# UNITED STATES PATENT AND TRADEMARK OFFICE

APPLICATION NO.	FILING DATE	FIRST NAMED INVENTOR	ATTORNEY DOCKET NO.	CONFIRMATION NO.
10/801,225	03/16/2004	Dirk Weichholdt	09242-US	2010
30689	7590	11/08/2005	EXAMINER	
DEERE & COMPANY ONE JOHN DEERE PLACE MOLINE, IL 61265			KOVACS, ARPAD F	
			ART UNIT	PAPER NUMBER
			3671

## Office Action Summary

2. Claims 1-8, 11-16 are rejected under 35 U.S.C. 102(b) as being anticipated by Roberg (EP 0631717 A1).

chopper fig 9, as it is shown in the marked up drawing below;

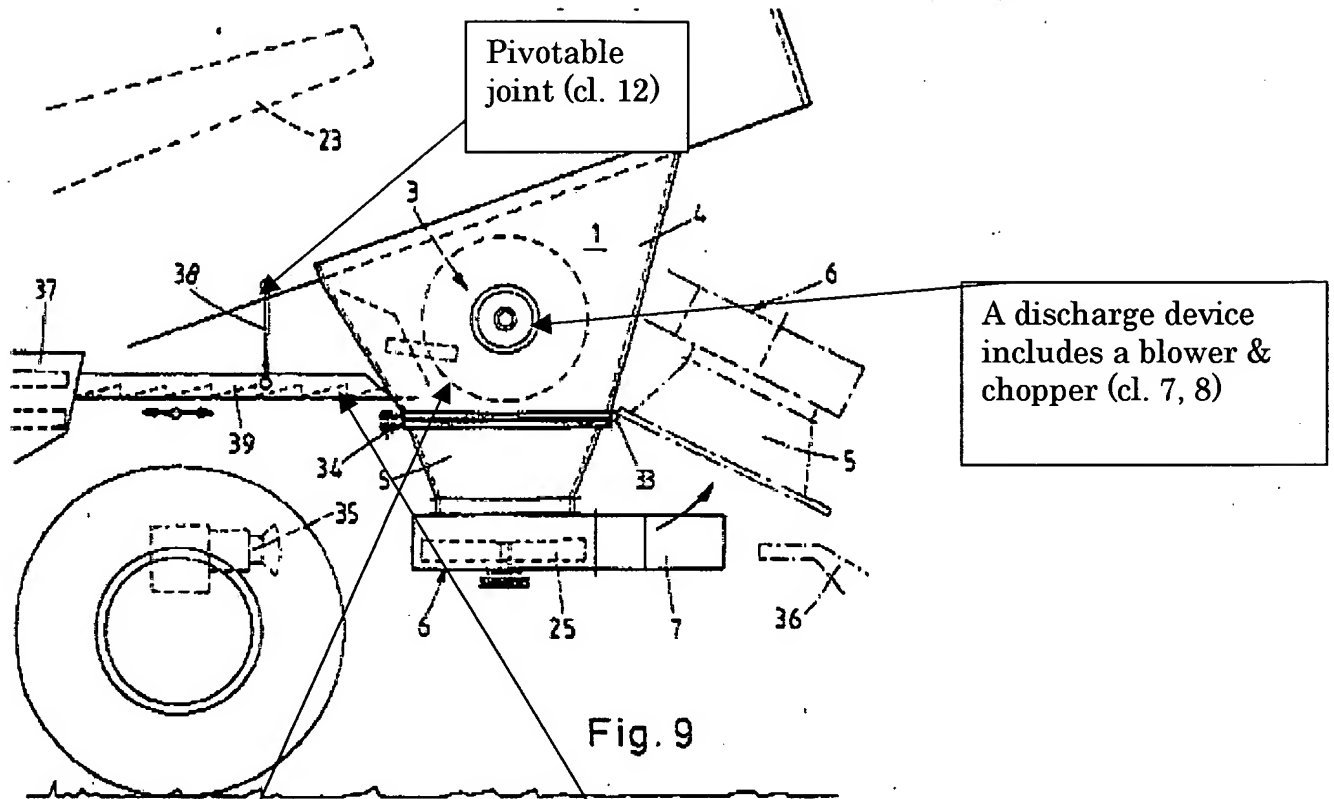
it is noted in re cl. 1 & 4, that the rotatable chopper (ref 3) receives material from left side, just below the counter blade / shear blade (shown in fig 9), therefore the step shaped shoulder or vibrating toothed conveyor is in the same housing;

the housing bottom / floor (39) is connected to the harvesting machine by means of an oscillating rocker (38) so that the function of: can oscillate in a direction of motion back and forth (see arrow in fig 9) for feeding residual crop material through the chopper (i.e. the back and forth motion can and capable of feeding material through the chopper);

direction of motion is tangential to the circumference of the chopper (1) & also, see drawing below;

step shaped shoulder at a front end of the bottom / floor for improved pushing of material through the chopper (note: without the step shaped shoulder the

material would not as aggressively move through the chopper; also, see drawing below);

as best shown in fig 9, or drawing below, the connection between the housing bottom & the shoe is mechanical, and the shoe is capable of setting the housing bottom into oscillating motion as shown by the left & right arrows;

pivotal joint as shown in the drawing below;

an oscillating floor bottom of the cleaning assembly (37) is rigidly connected to the housing bottom

Chopper's circumference tangential to the bottom (cl. 2, 5)

An oscillating bottom (of the housing) can be moved back & forth as shown by the arrow (cl. 1, 4); with stepped shaped shoulder (cl. 3, 6), inherently mechanically connected to the cleaning shoe, can be set into an oscillating motion by movement of the cleaning shoe (cl. 11)
